**RE: Holly Street Landfill Periodic Review**

Thank you for taking the time to consider our comments on the First Periodic Review for Holly Street Landfill in Bellingham, WA. We have concerns that this historic landfill may be contributing pollution to Bellingham Bay and would like to see a plan in place to investigate and remediate any pollution problems in a timely manner.

An example of an antique glass bottle excavated from the northern bank of Whatcom Creek during a beach cleanup.

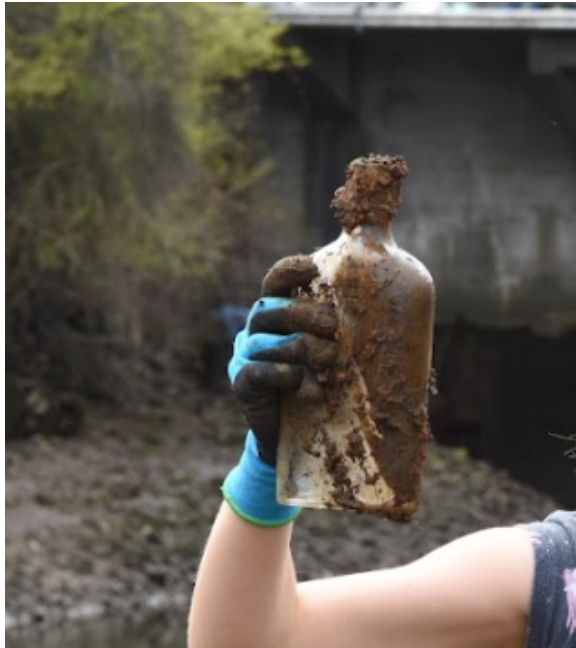
According to the Remedial Investigation, the interaction of water with the historic refuse is one of the main sources of pollution at this site. After removing over 12,000 tons of waste a cap was placed over the remaining refuse to prevent this water-refuse interaction. We are concerned, however, that this cap is not intact. For the past 5 years, from 2020 to 2024, RE Sources has conducted annual trash cleanups at Maritime Heritage Park. We consistently remove over 200 pounds of trash from this site which is, on average, more than our other cleanup sites. While some of this trash is modern day litter, there is a considerable amount of trash that appears to be historic trash. In 2023, in particular, the cleanup occurred in February during a very low tide. Volunteers collected over 1,000 pounds of garbage in 2 hours. People were finding old, large chunks of industrial metal, tubing and piping, vintage metal dishware, and lots and lots of old glass in the sediment on either side of the creek (both intact bottles and shards). It seemed that people were finding more of this material

on the northern bank than the southern bank. While bathymetric surveys performed in years 1, 5, and 9 post cleanup claim the integrity of the shoreline cap is intact, the routine presence of historic garbage on the surface of the sediment challenges this claim. ***We would like to understand the source of this historic garbage being found at our annual trash cleanups and know if it is posing a threat to the water quality of the creek.***
